SERVICE NO. 1423A BULLETIN

Date: May 13, 2025

WING AFT SPAR-TO-FUSELAGE ATTACHMENT HARDWARE INSPECTION

SB 1423A updates select serial numbers, revises instructions for clarity, in particular step 3.a to clarify the purpose of the torque values listed are for performing an off-torque (i.e., loosening torque) test of the bolt head, and revises instructions to direct customers to contact a DER for a suitable repair when a condition exists that is outside the scope of this service bulletin.

Figure 1
Typical Panel Location (Under RH Wing)

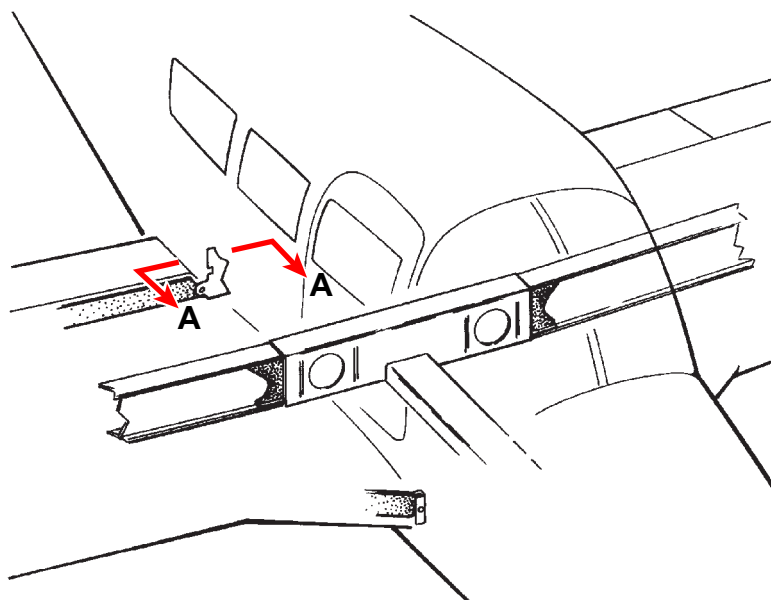
1. Remove the lower wing-to-fuselage fairing in the area of the wing aft spar. See Figures 1 and 2.
2. Lower the flaps to gain access to the head of the aft wing-to-fuselage attachment bolt.
3. Examine bolt to determine the nominal diameter. Inspect the bolt in the fittings.
 - a. Verify the bolt is secured by performing one of the following actions:
 - Visually confirm the bolt head or nut has an unbroken torque stripe.
 - Perform an off-torque (i.e., loosening torque) test to confirm the bolt head does not loosen (e.g., does not rotate in the counter-clockwise direction) when the following torque value range is applied:
 - For 5/16 inch diameter bolts, off-torque value is 100–115 in-lbs minimum.
 - For 3/8 inch diameter bolts, off-torque value is 180–195 in-lbs minimum.

Figure 2
Wing-to-Fuselage Attachment Bolt Location

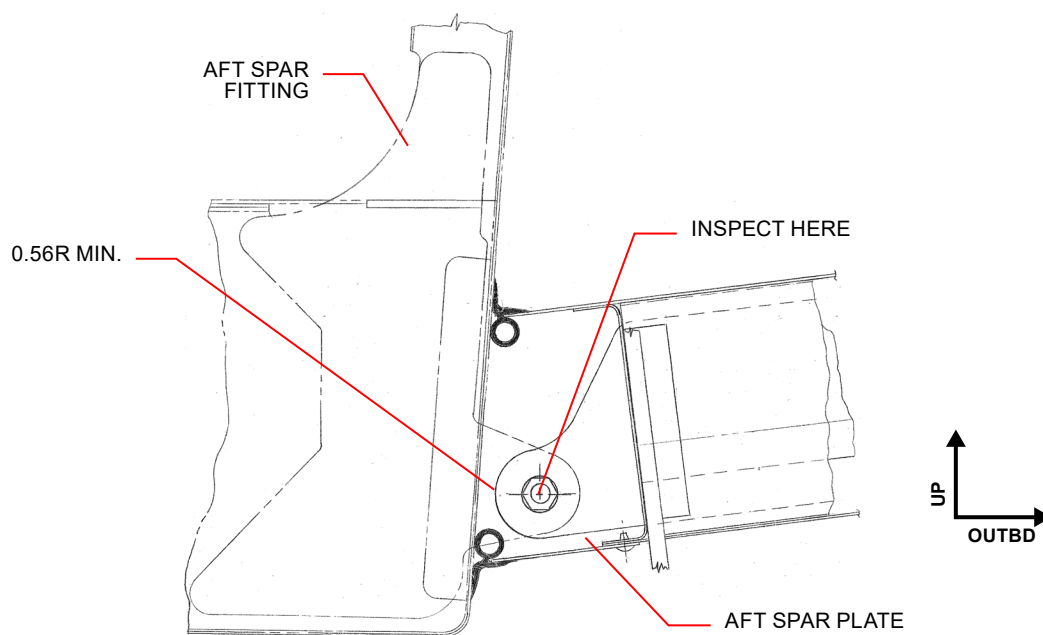
If the bolt is secured, no further action is required. Proceed to step 4.
If the bolt is not secured, further action is required. Proceed to step b.
 - b. If the bolt head or nut has a missing/broken torque stripe or the bolt fails the off-torque test described in step a, perform the following:
 - 1) Remove the attachment hardware (bolt, washer, and nut – retain/replace hardware on condition) to inspect the holes in the fittings for size and make sure no out-of-round condition exists outside of allowable limits. The specified hole size is as follows:
 - For 5/16 inch diameter bolts, the specified hole size is 0.3115–0.3135 inch diameter.
 - For 3/8 inch diameter bolts, the specified hole size is 0.3745–0.3765 inch diameter.
